# Addendum

This addendum is applicable to the following documents:
Series **ezPAC™** for SA310/SA320/SA330 R option devices
- Installation Manual – BG0325;
- Operational manual – BG0346.

Figure 1: Dual Ethernet Port ezPAC top view.

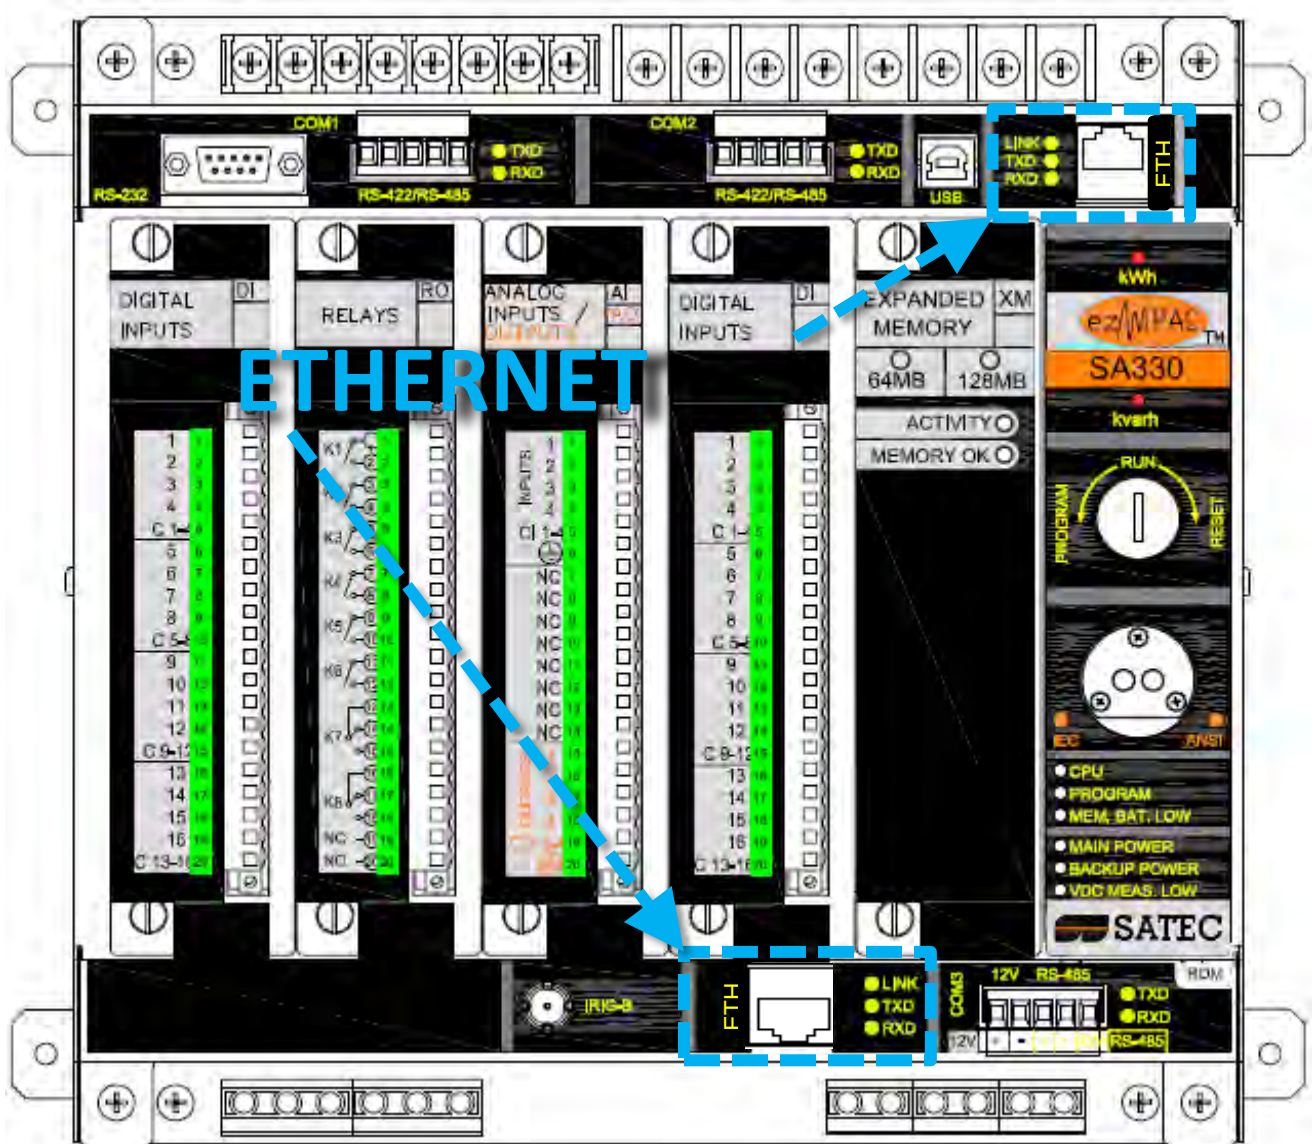
Dual ETH port option description:
This SA3xx series option provides two Ethernet Communication ports: PORT-A & PORT-B, see the figure below.

The dual ETHERNET ports SA3xx option cannot support the internal Embedded 56K dial up modem.

The additional ETHERNET port (B) provides 10/100Base T redundancy line.
Both ports, A and B, are connected to 10/100Base lines, while only one of them is active.
If the active line is damaged or disconnected or not available for at least 10 seconds, the IED SA3xx0 series will switch automatically to the other port, followed by LEDs port indications.
